Addendum #3 File # 17-0445 Harrison Park Improvements – Phase 1

ADDENDUM NUMBER 3

DATE: July 11, 2017 PROJECT: Harrison Park

L-3.1

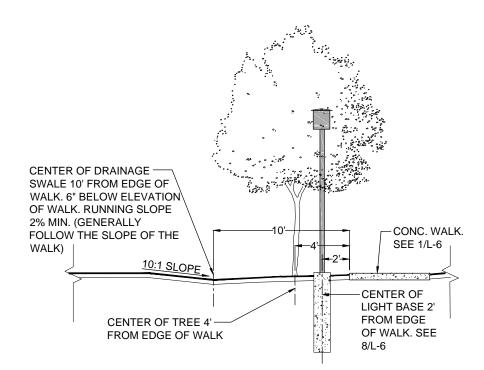
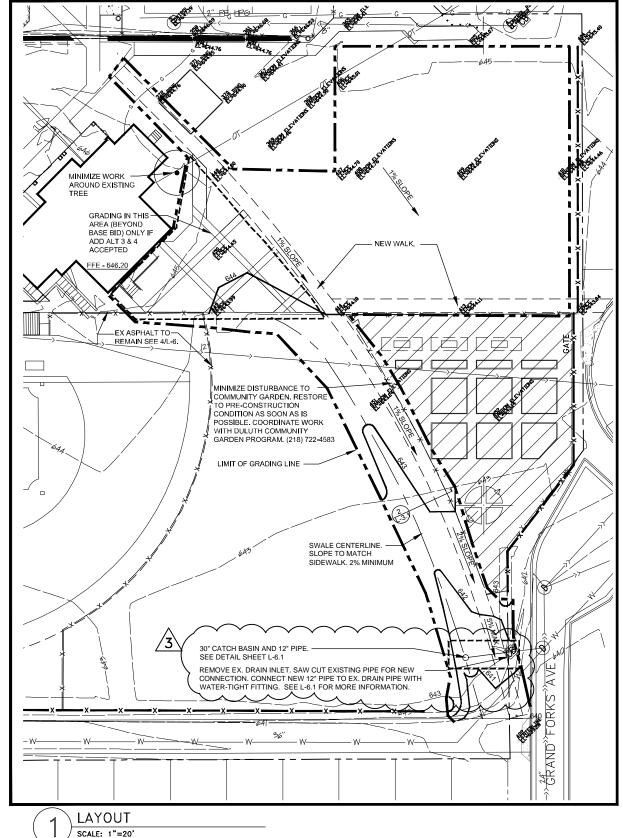
SHEET L-6.1

Addition of new catch basin, pipe and drainage information.
